Lendlease Building
Fort Street Public School
Construction Traffic Pedestrian
Management Sub Plan

REP-02

Issue | 25 March 2021

I refer to the attached Construction Traffic Pedestrian Management Sub Plan for the redevelopment of Fort Street Public School, to satisfy Condition B18 of SSD 10340. We have reviewed the report and provide the following comments:

Figure 6: Hoarding boundary line for Bradfield Tunnel Services Shed modification works

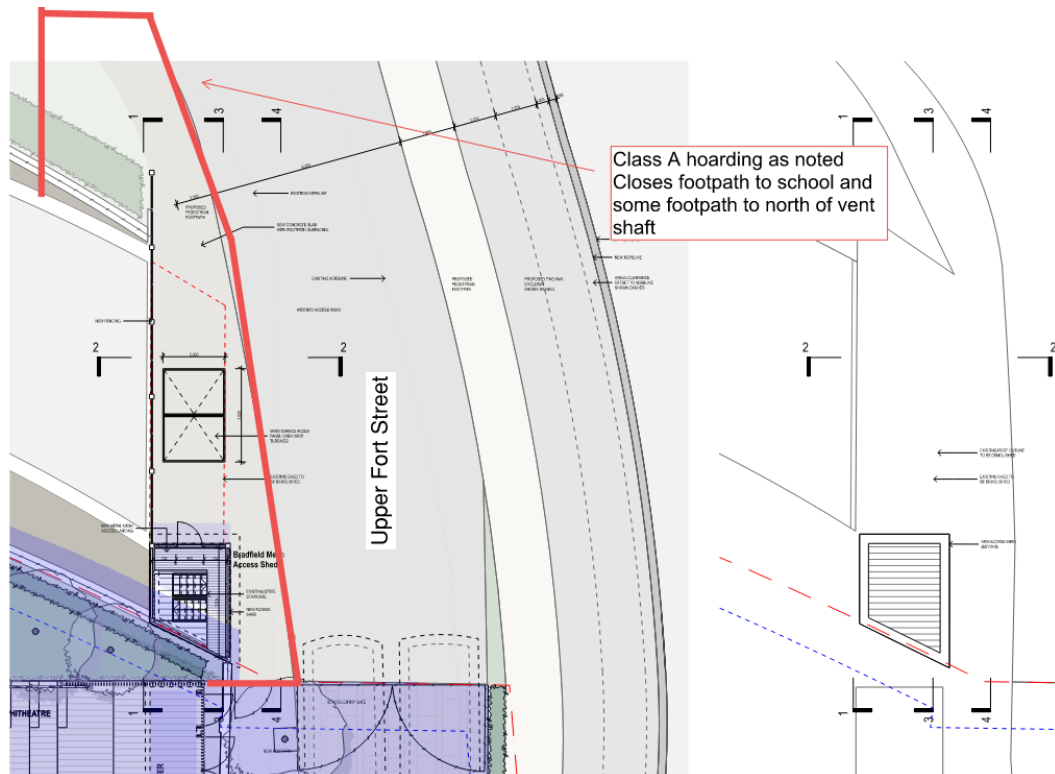
1. Figure 6 (page 11) shows hoarding installed across Upper Fort Street for the Bradfield Tunnel Services Shed and the widening of Upper Fort Street works. How will access for pedestrians and cyclists be maintained during these works?
2. The existing path between Kent Street (<https://goo.gl/maps/exRpznKht8FmksXq5>) and Upper Fort Street (<https://goo.gl/maps/znyWwokBU2xwM3Mz6>) is a shared path. Section 4.2 and 4.3 should identify the proposed diversion as a shared path for pedestrians and cyclists and not only a 'cycleway'. Shared path signs and line marking are to be installed on the proposed diversion to reinforce that the path can be used by both pedestrians and cyclists.
3. Figure 20 (page 24) shows the truck departure route accessing the Western Distributor from Sussex Street at King Street. Vehicles are to access the Western Distributor from Sussex Street at Market Street.

To maintain access for the shared path past the hoarding while the Bradfield Tunnel Services Shed works are occurring, pedestrians will also be required to walk along the roadway through the pinch point. As a result, this area (shown in Figure 18) has been proposed to operate as a shared zone, with the traffic controller located north of the pinch point responsible for holding pedestrians, cyclists and vehicles at this location.

This would only be required during the works involving the Bradfield Tunnel Services Shed and pinch point widening, or until the hoarding can be moved to the current shed wall and the pedestrian footpath restored.
